TC 304-06 Mercer/Covey
SUB 1076

Re: M1076
Mercey-Covey Subdivision and Lot Line Abandonment

Re: M1076 Mercer-Covey-Revised
TM 25, Parcels 43 & 86

Re: M1076 Mercer-Covey
TM 25, Parcels 43 & 86

SHEET No. 4 OF 5
 FILE No. A554

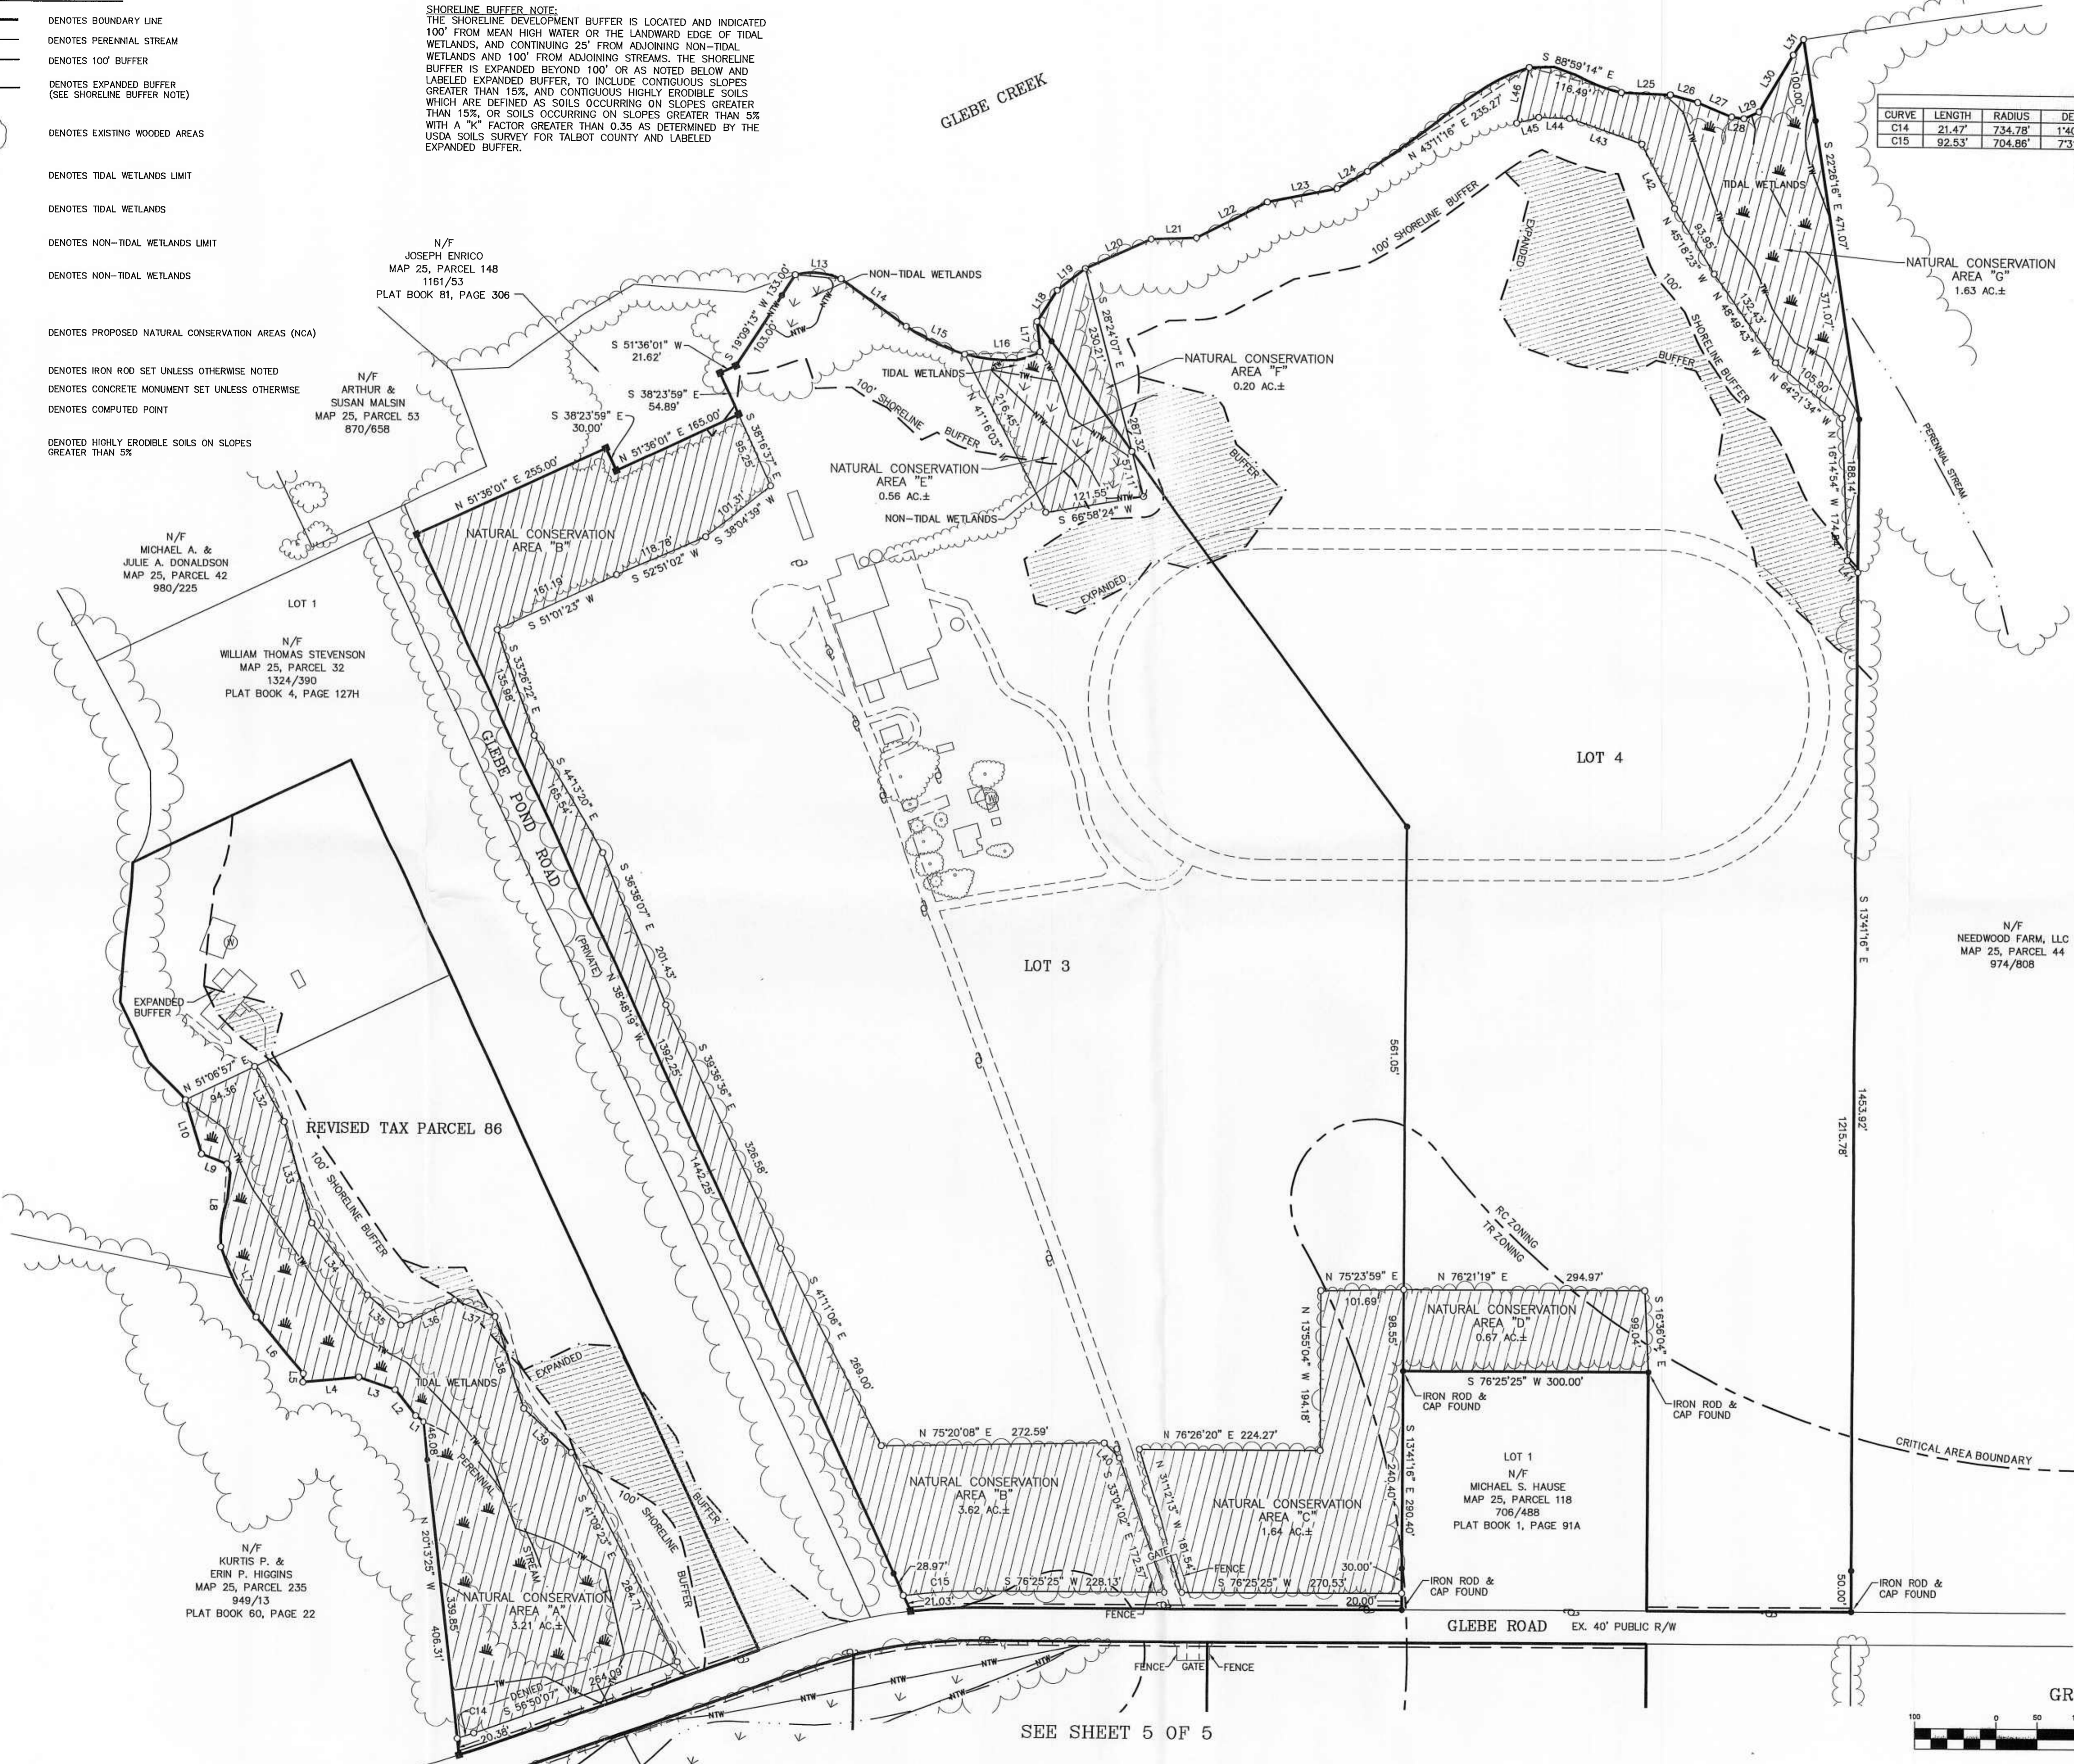
1. It is my understanding that the acreages of the reservation of development rights areas shown on sheet 2 are not accurate. While Commission staff was able to obtain the correct acreages from Mr. Stagg, this information should be corrected on a revised subdivision plat.
